SUBJECT: Forwards response to RAI re review of request for amend dtd 970929 for TS related to main steam line isolation signal setpoints.

Subject: Response to Request for Additional Information (RAI)
Rochester Gas & Electric Corporation
R.E. Ginna Nuclear Power Plant
Docket No. 50-244

Reference: Letter from G.S. Vissing, NRC, to R.C. Mecredy, RG&E, Subject: *Request for Additional Information - Review of Request for Amendment Dated September 29, 1997 - Change to the Technical Specification Related to the Main Steam Line Isolation Signal Setpoints (TAC No. M99702)*, dated April 3, 1998.

Response to RAI of April 3, 1998

Figure 7

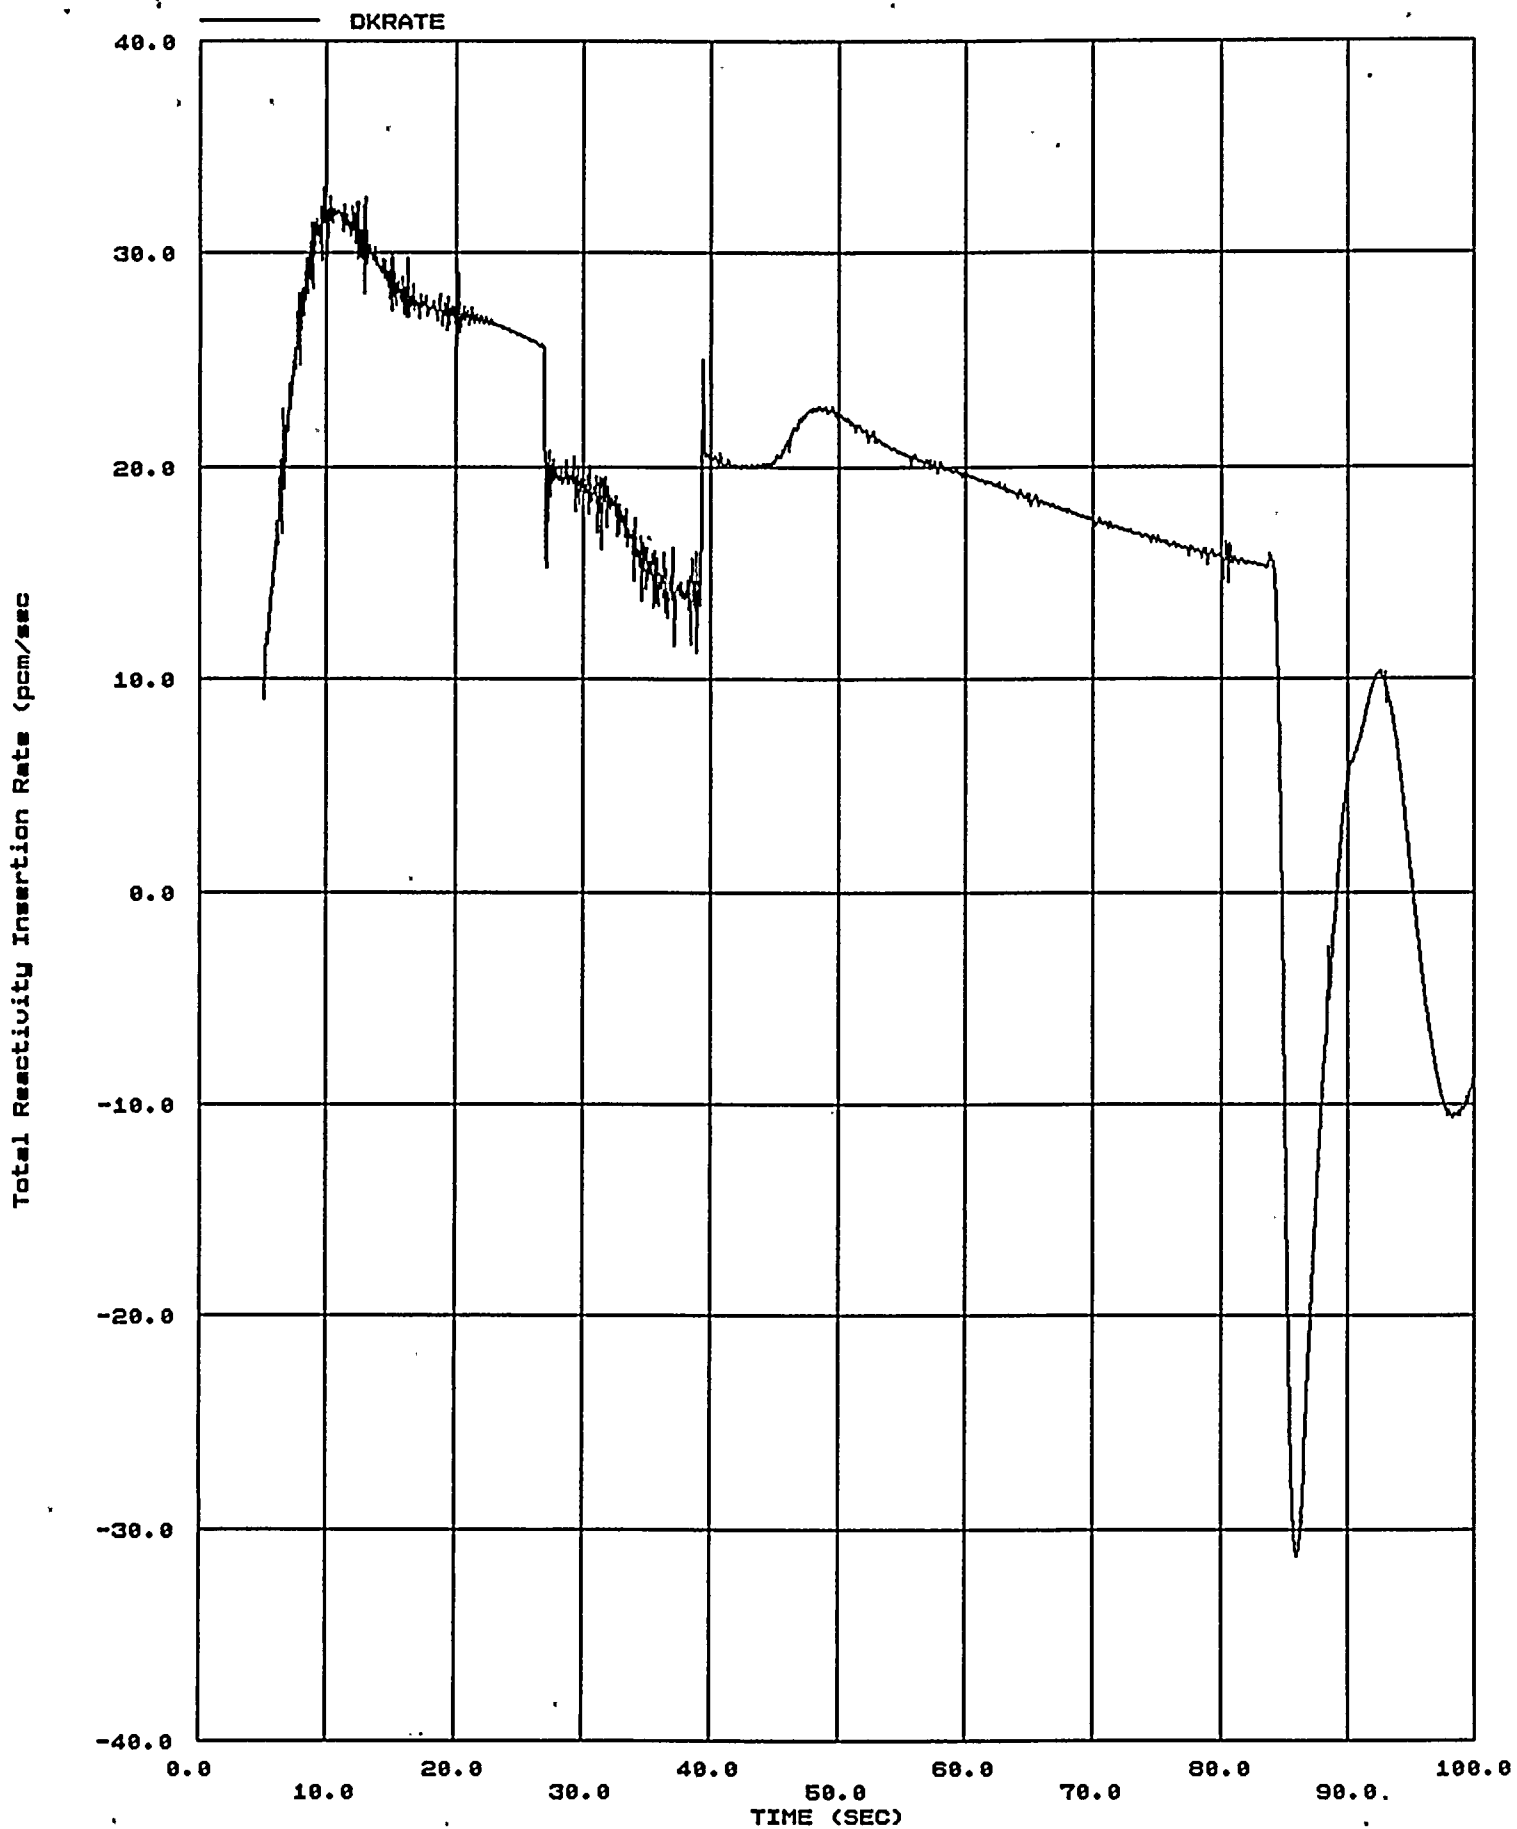
2. *Please provide the results of your reanalysis.*

Attached Figures 1 through 7 represent parameters from Case 5-O. Figures 8 through 14 represent parameters from the 0.66E6 lbm/hr steam line break in one steam generator described in the February 6, 1998 RG&E letter (hereafter referred to as Case SLB). A comparison of the parameters shows:

- a. Resulting nuclear power is less for Case SLB;
- b. Resulting RCS temperature reduction is less for Case SLB;
- c. Resulting pressurizer pressure reduction is less for Case SLB;
- d. Resulting steam generator pressure reduction is less for Case SLB;
- e. Steam generator mass trends illustrate the difference between a feedwater malfunction and a steam break;
- f. Total reactivity insertion is less for Case SLB but occurs over a longer time frame; and
- g. The rate of reactivity insertion is less for Case SLB.

In summary, the parameters indicate that the Case SLB is less severe than Case 5-O and that the limiting criteria with respect to the reactivity insertion rate is less than that for Case 5-O. Therefore, UFSAR Case 5-O remains bounding.
